JAMESTOWN ACTIVE TRAVEL SCHEME

Preliminary Design Report

RGW-RP-AL-0002-P02

**Stage 1/2 Road Safety Audit
Proposed Active Travel Scheme,
Jamestown, Co. Roscommon**

DRAWING NUMBER	REVISION
RCW-DR-GA-0001	P02

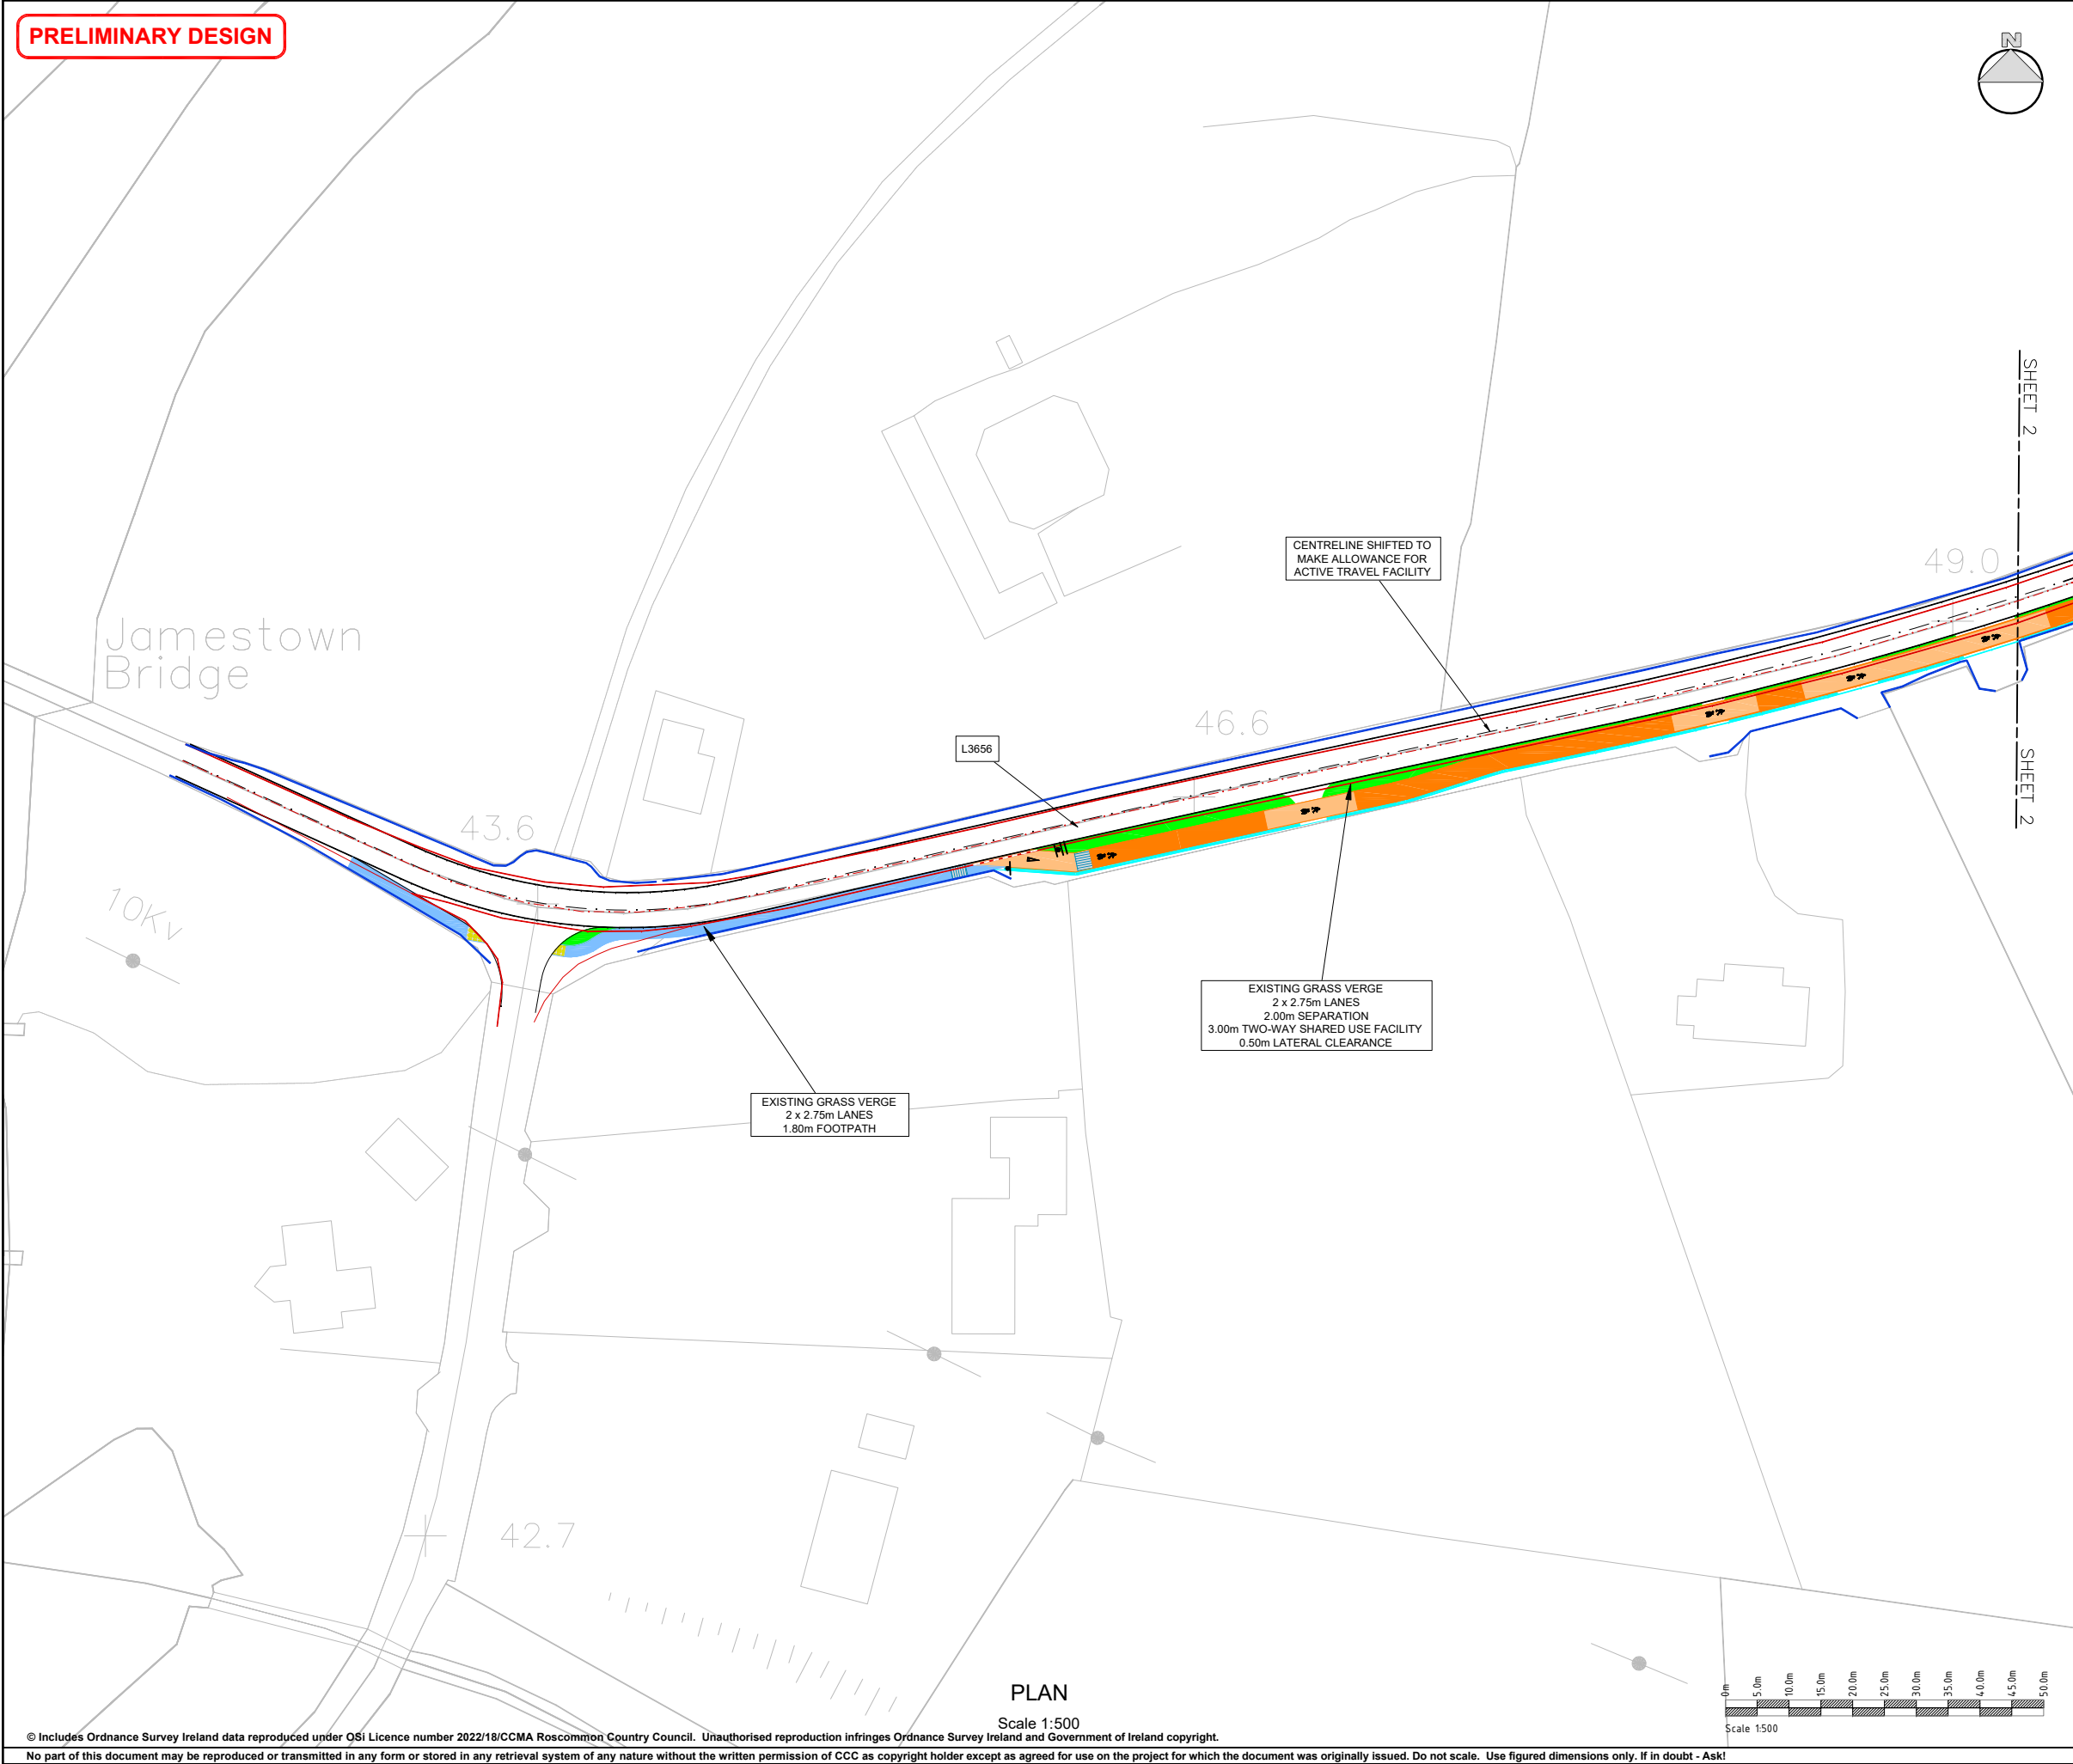
Problem No.01: Pedestrian Permeability

Location: L3656 Junction (Drawing No. RCW-DR-GA-0001)

The audit team has observed from the provided drawings that the proposed pedestrian path appears to terminate abruptly at the western side of the junction, with no clear connection to an existing pedestrian footpath network. This lack of continuity and insufficient pedestrian permeability may pose significant risks to vulnerable users who are forced to transition directly into the roadway at these termination points.

The absence of a seamless connection between the proposed pedestrian paths and an existing footpath network raises concerns for pedestrian safety. Without a smooth transition, pedestrians may encounter difficulties navigating the area and be exposed to potential hazards while crossing the road. This situation increases the likelihood of conflicts with vehicular traffic and heightens the risk of accidents and injuries, particularly for vulnerable road users.

The design team should review the footpath layout in this area to ensure interconnectivity with surrounding footpaths.

DRAWING TITLE
 GENERAL ARRANGEMENT
 JAMESTOWN
 SHEET 2 OF 4

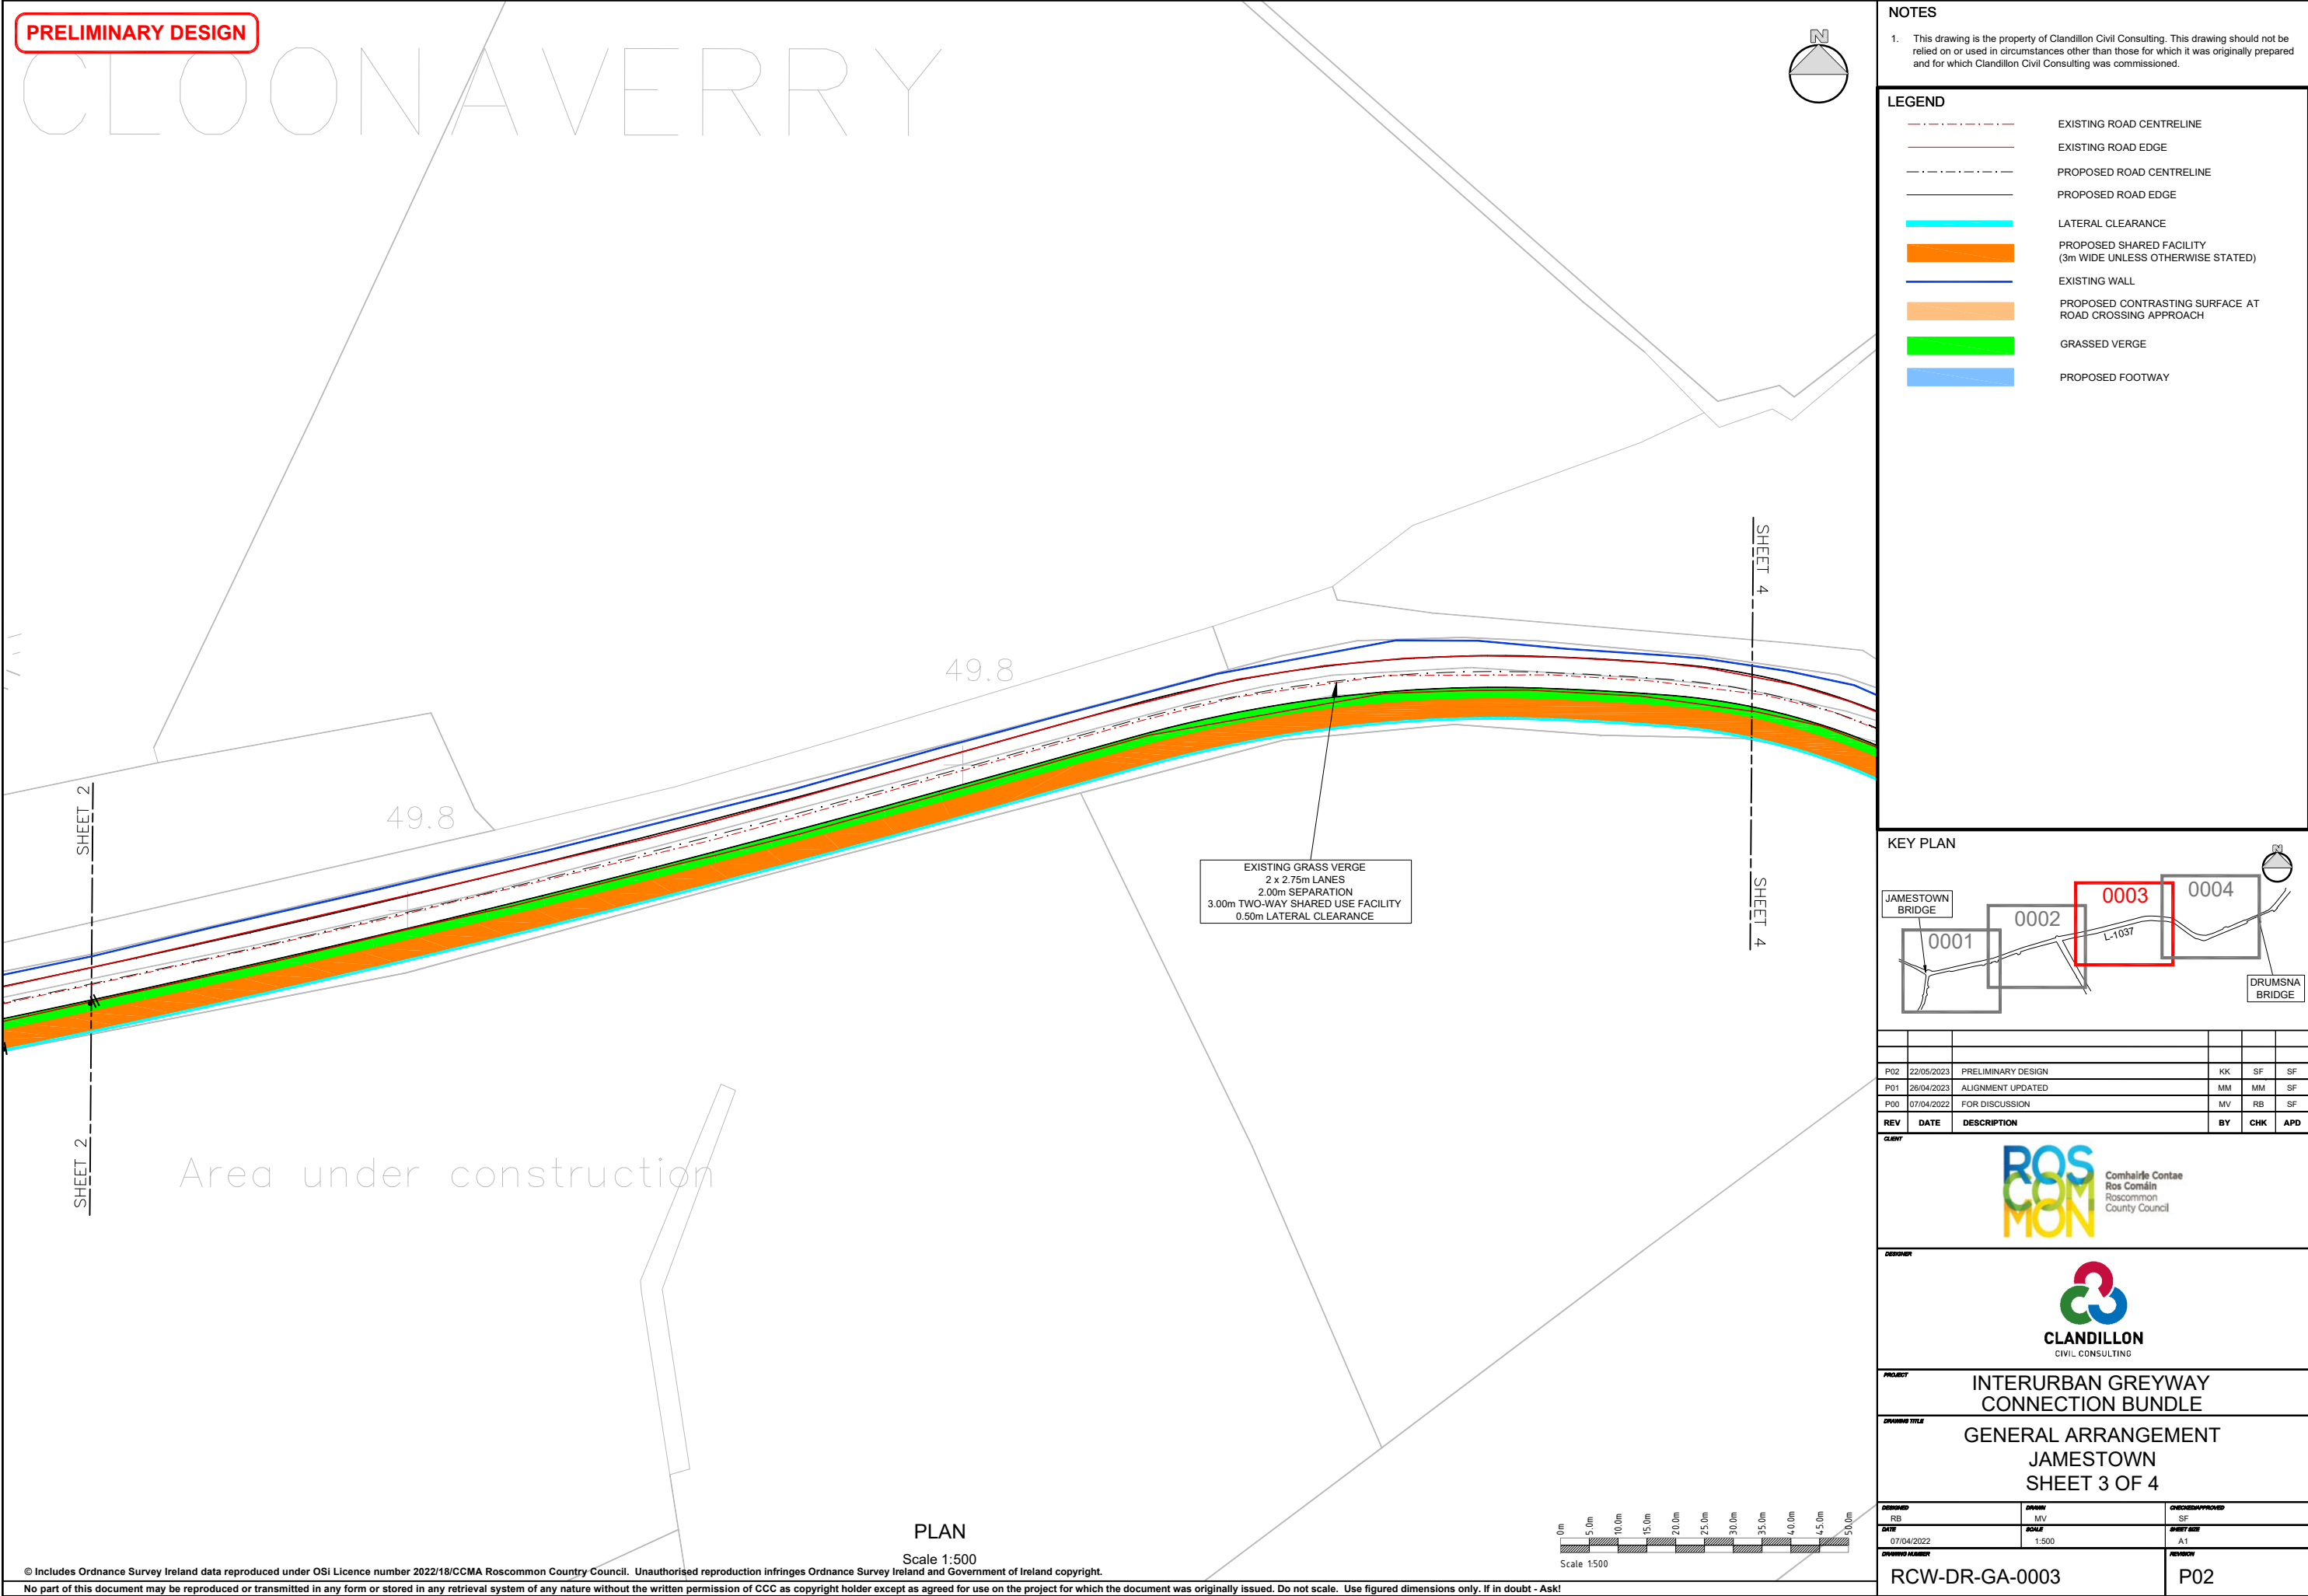
Problem No.03: Vulnerable User Sightlines**Location: Bend-Out Crossing Point (Drawing No. RCW-DR-GA-0002)**

The audit team has observed that there is a bend-out crossing point proposed along the shared route. However, the team also note that there are no detailed sightlines provided at this new crossing arrangement at the junction. This lack of sightline provision for vulnerable users may lead to unsafe manoeuvres when users are departing from these locations, potentially resulting in vehicle/bicycle/pedestrian collisions causing injuries.

The design team should ensure the adequate sightlines are achievable at the junction and that the entire extents of sightline availability is detailed on the proposed plans.
